Service Bulletin SB-0025

Subject: Wire Routing Improvements

Effectivity: K003 – K021

Affected Model(s): E1000, E1000 GX

o. Empennage – Autopilot Servos

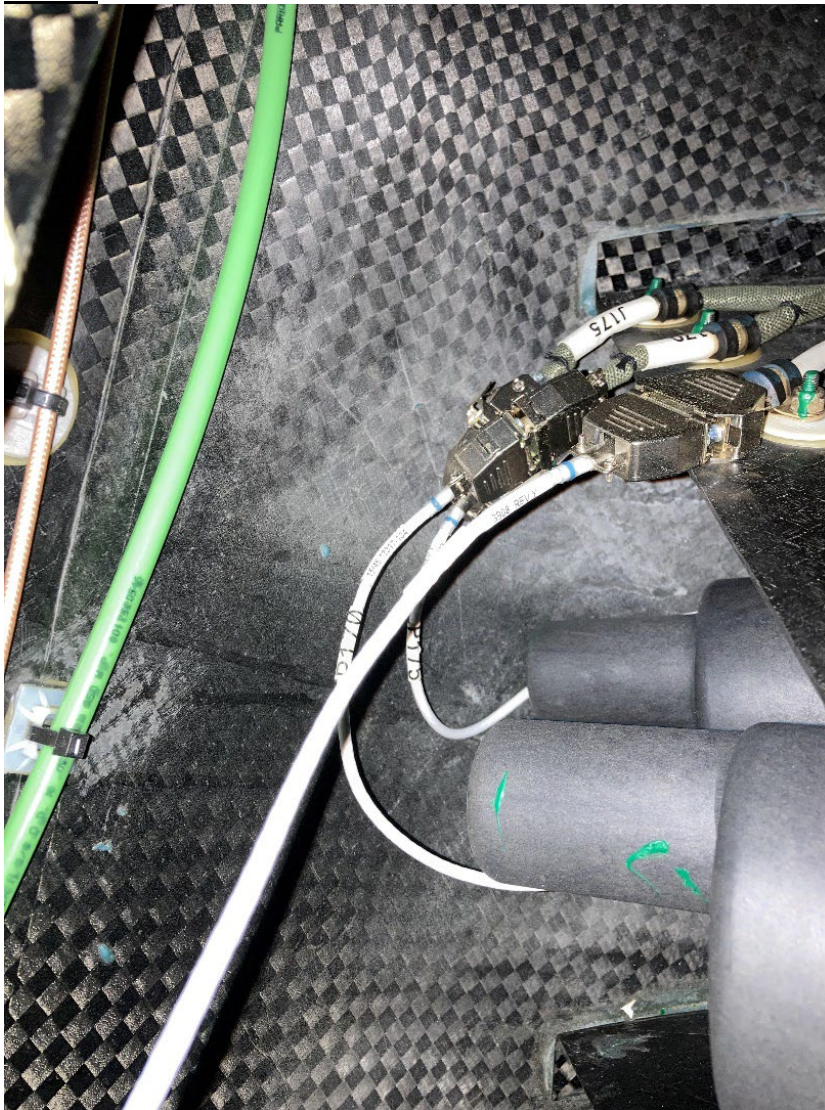
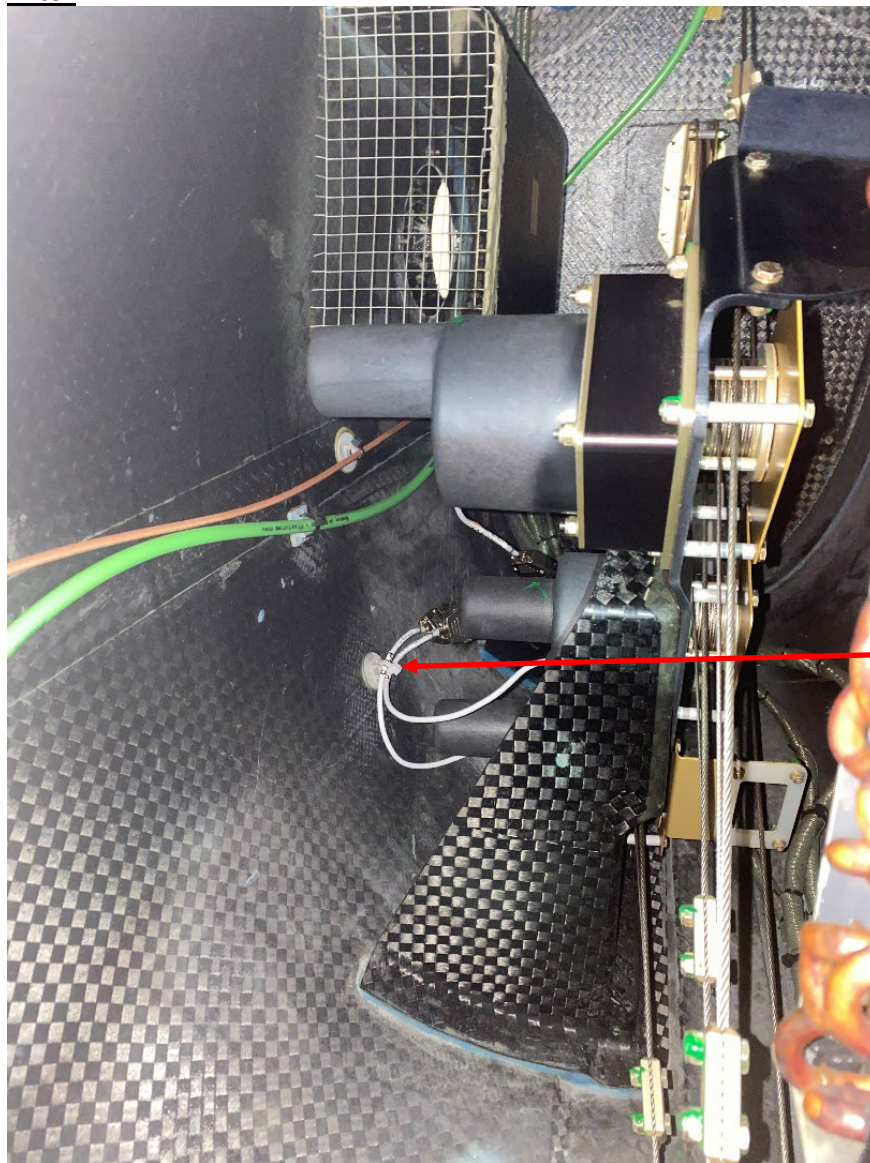
Action: Add tie mount to secure loose wires.

Add tie mount as shown.

p. Vertical Stabilizer – Magnetometers

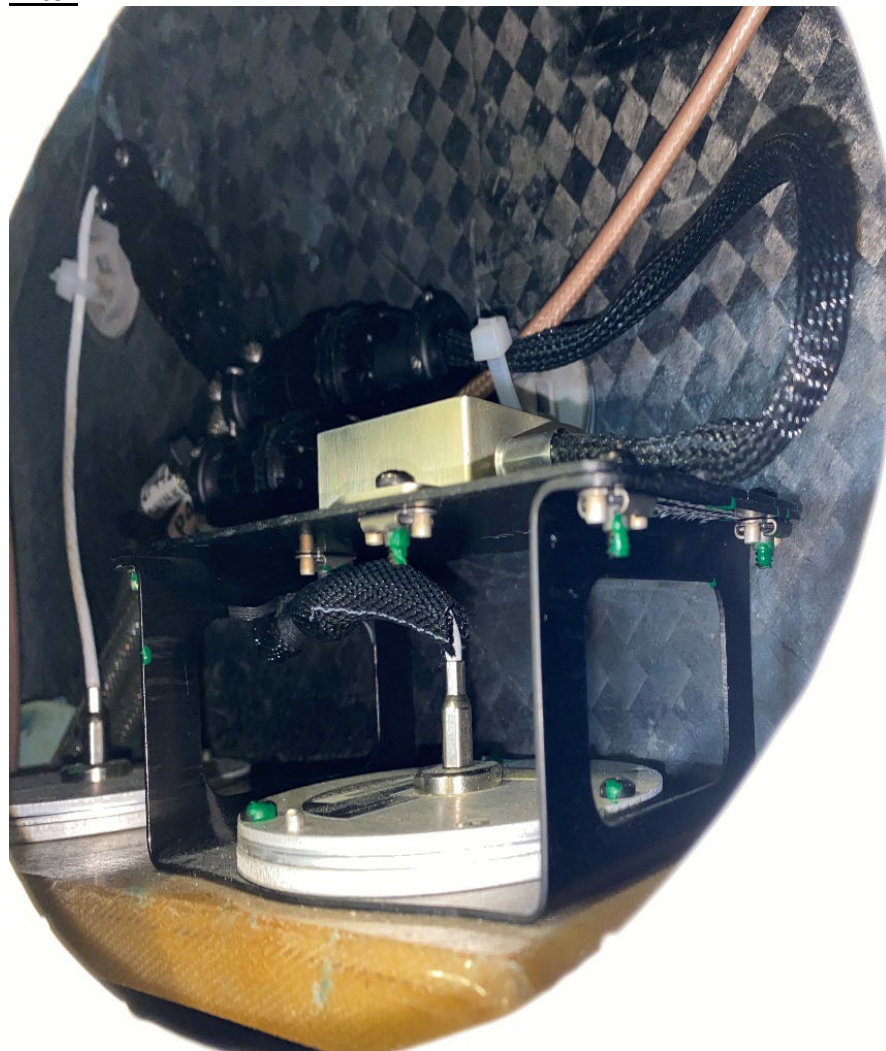
Action: Add 3 more tie mounts for the 3 connectors along with existing single point tie mount.

q. Underfloor – Ground Wires

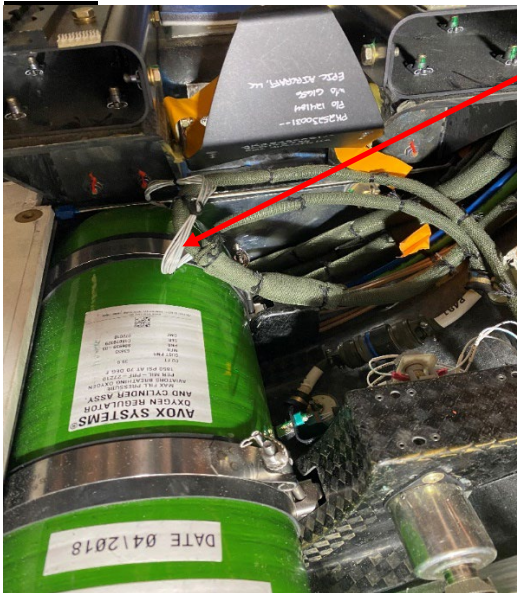
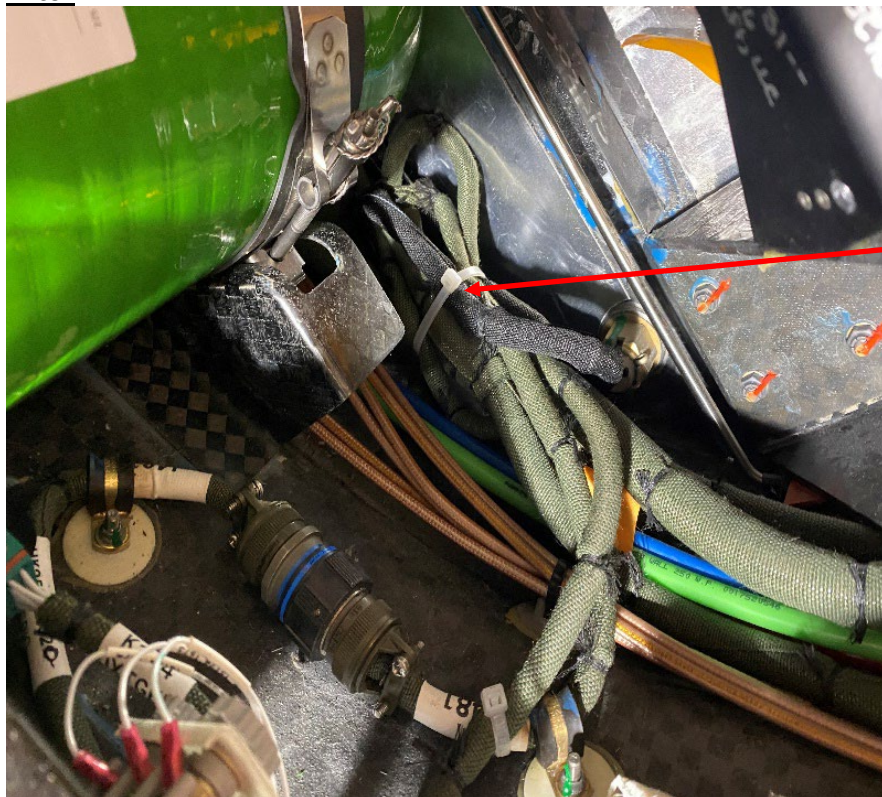
Action: Install Roundit on ground wire bundle up to the TS101/102 ground block.

Ground wires.

Install Roundit
and route with
other harnesses
using a tie-wrap.

r. Empennage – Aft Bulkhead, Right Side

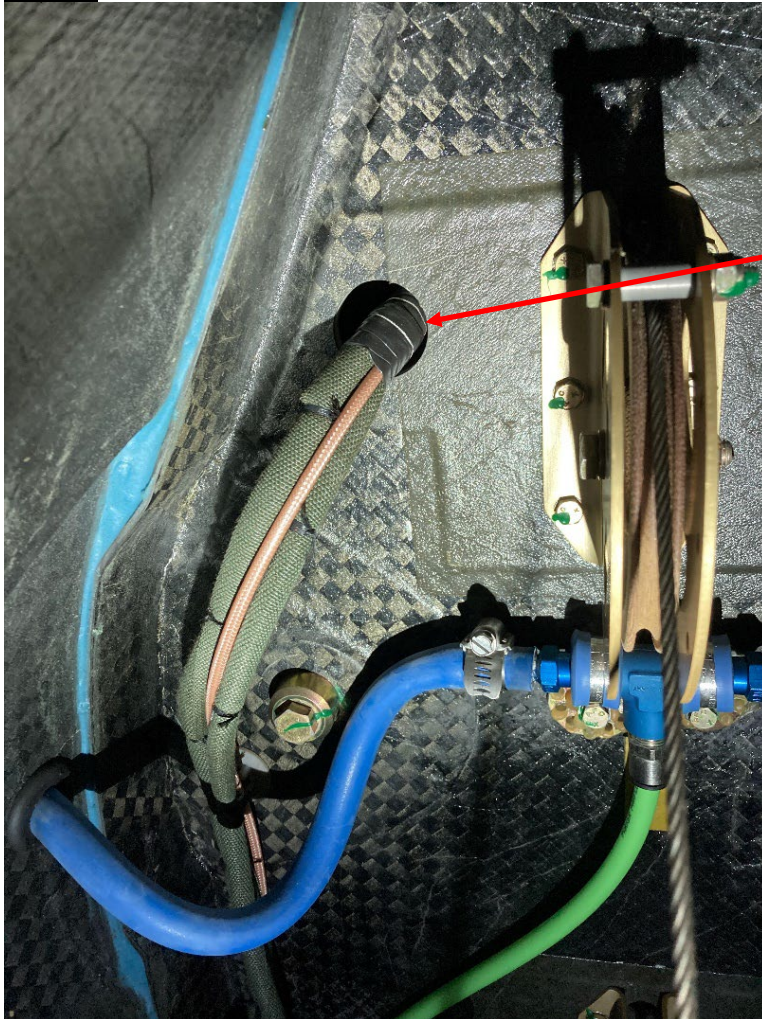
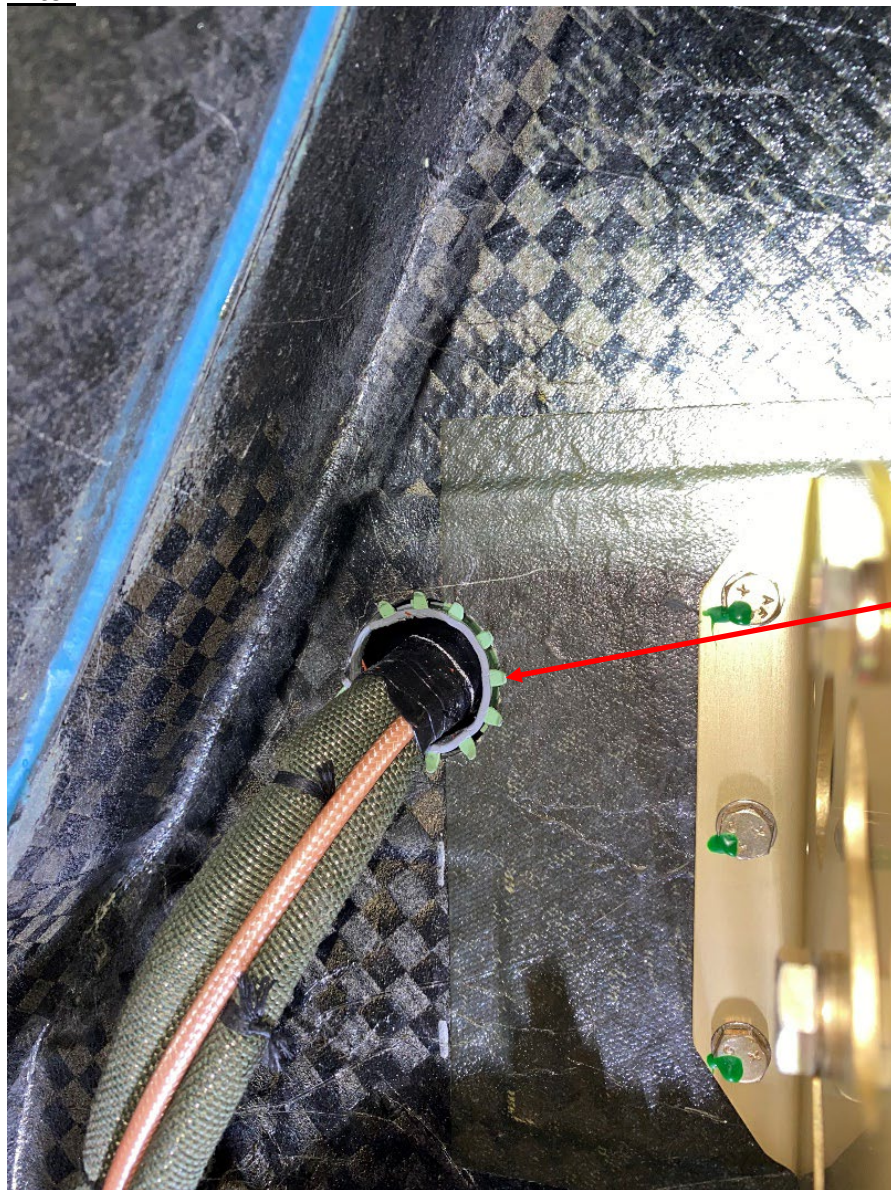
Action: Install edge protection at the pass-through hole.

Chafe hazard.

Add edge protection.

s. Fuselage – Cabin Door

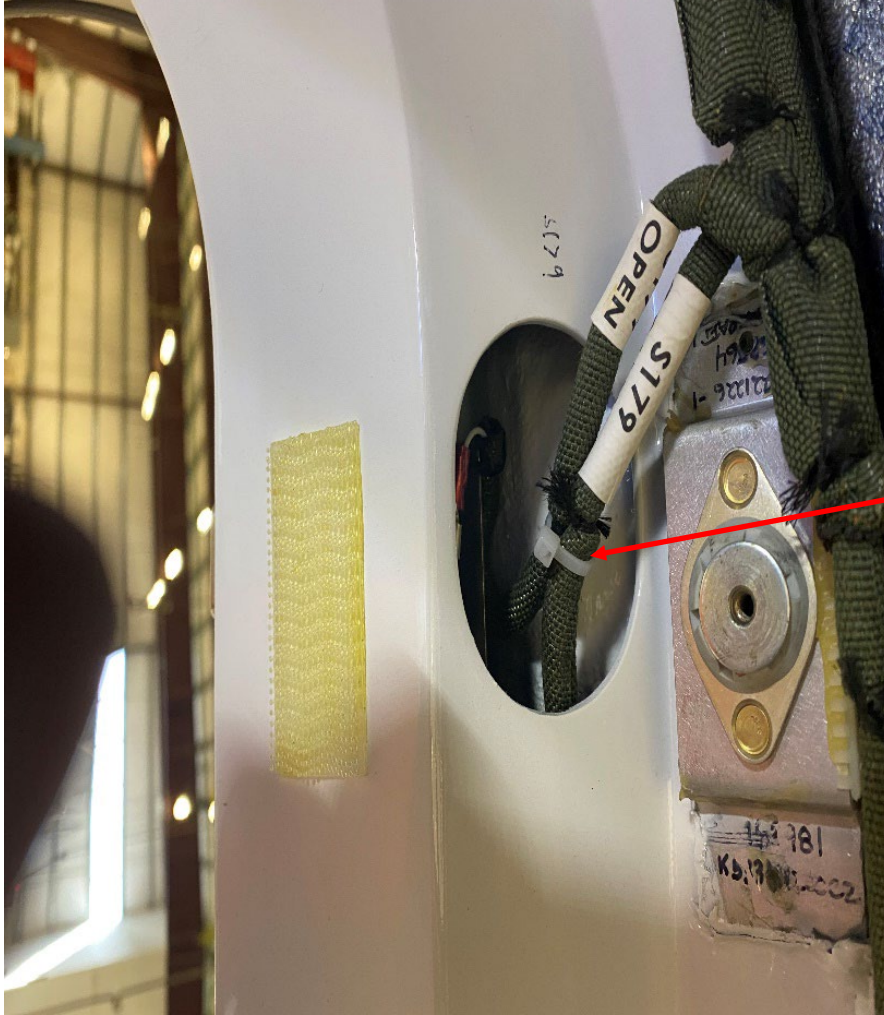
Action: Added tie straps to help secure wires for door sensors, at 8 different locations around the doorway

Add tie straps at
8 door switches.

t. Wing Tip Fuel Sensors

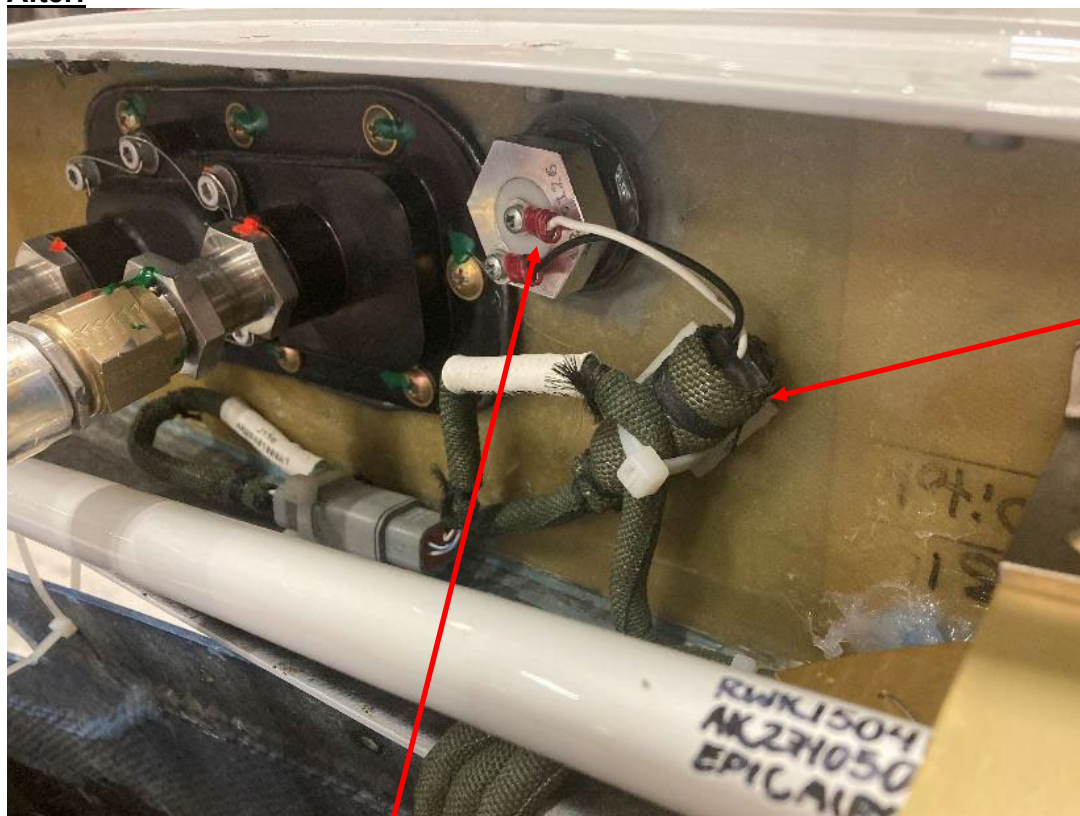
Action: Install tie mount to prevent the harness and connector from contacting the nutplates. Re-clock the terminals on the fuel probe and install tie mount to secure the harness on the wing rib.

Re-clock
terminals.

Install tie mount
to secure the
harness to the
wing rib.

u. Firewall Forward – Fuel Flow Sensor

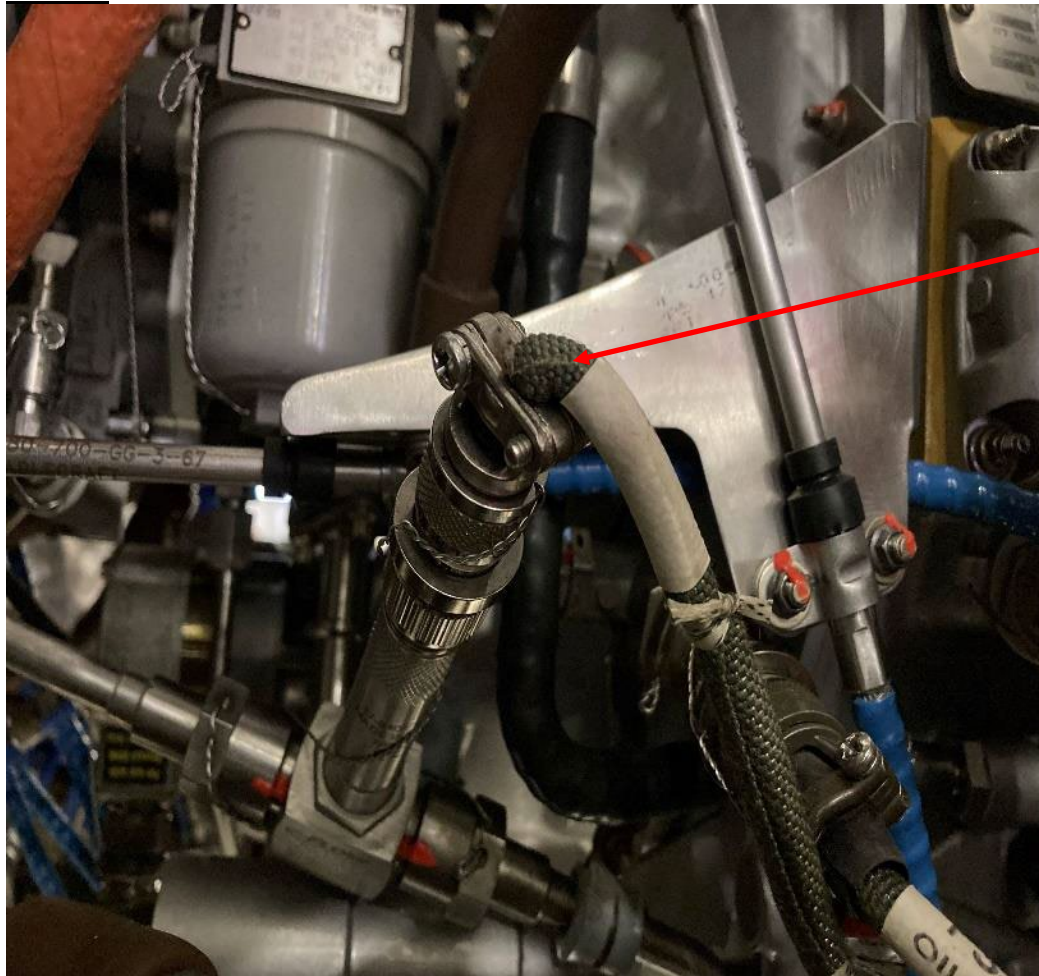
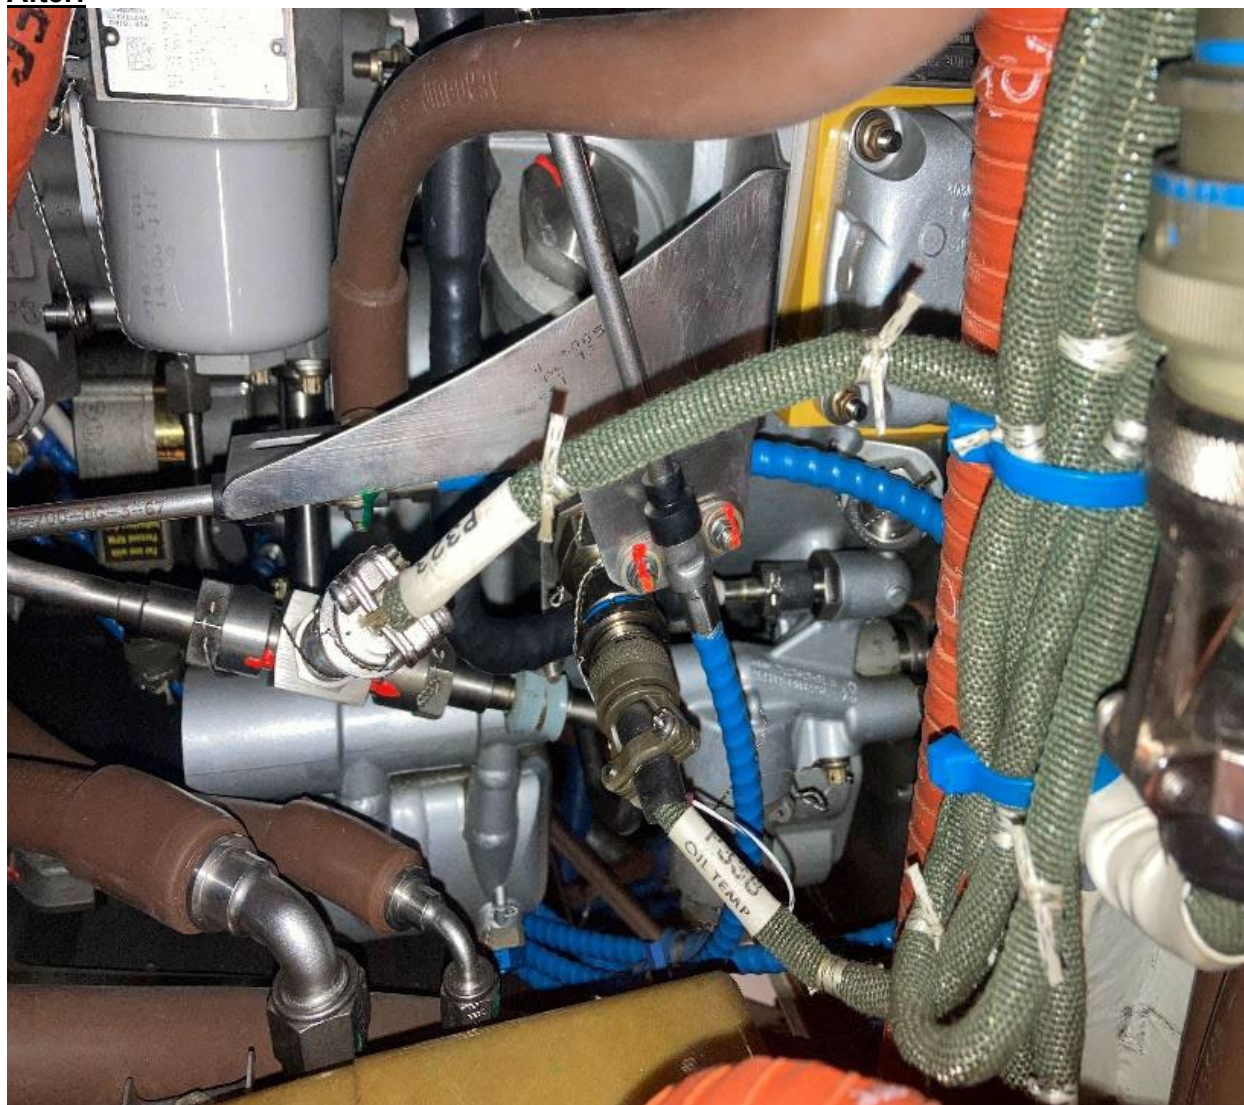
Action: Re-rout harness as shown to relax tight bend.

Excessive
bend.
